©Kawasaki Motors Corp. 1974 Printed in USA

NOTE: For further information on Z1 shift problems, see Bulletin Ser. '73 Z-23.

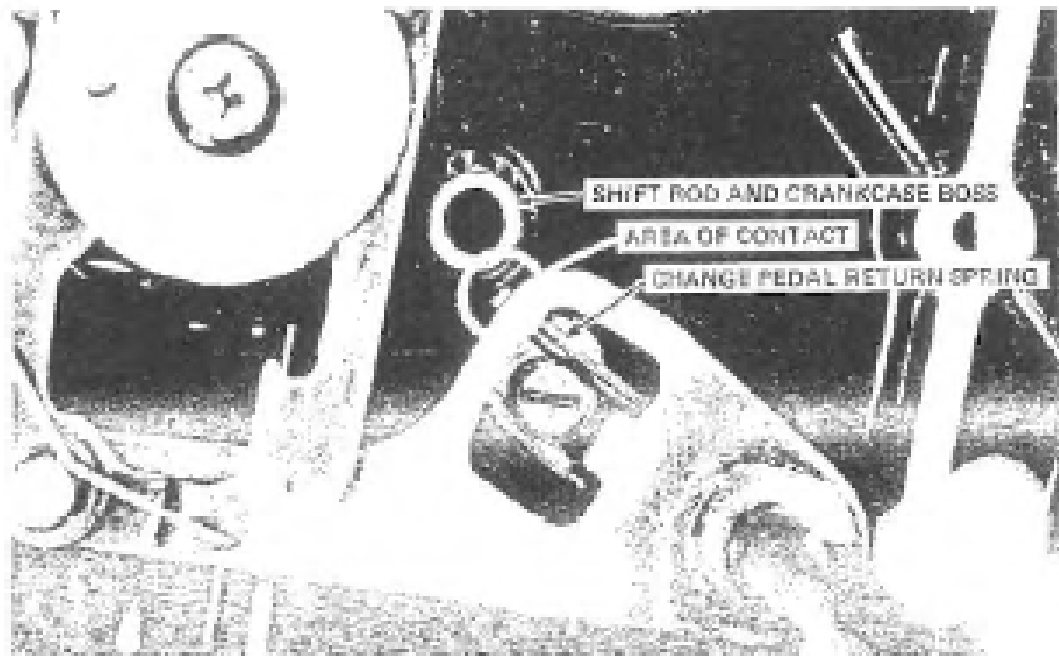
On some Z1 models, the change pedal return spring contacts the crankcase when an upshift is attempted. Several different upshifting problems can result.

When the shift pedal is in the middle position, one end of the change pedal return spring is very close to the crankcase shift rod boss and moves even closer when an upshift is attempted. The spring contacts the boss and produces any of the aforementioned problems.

To prevent the change pedal return spring from striking the crankcase, the manufacturing tolerances of the spring length have been changed. This new spring is used in Z1 production beginning with engine Number Z1E-D4821. To correct upshifting problems that are caused by an old style return spring, either a new style return spring can be used as a replacement or the old style spring can be modified by removing 1-2mm from the ends.
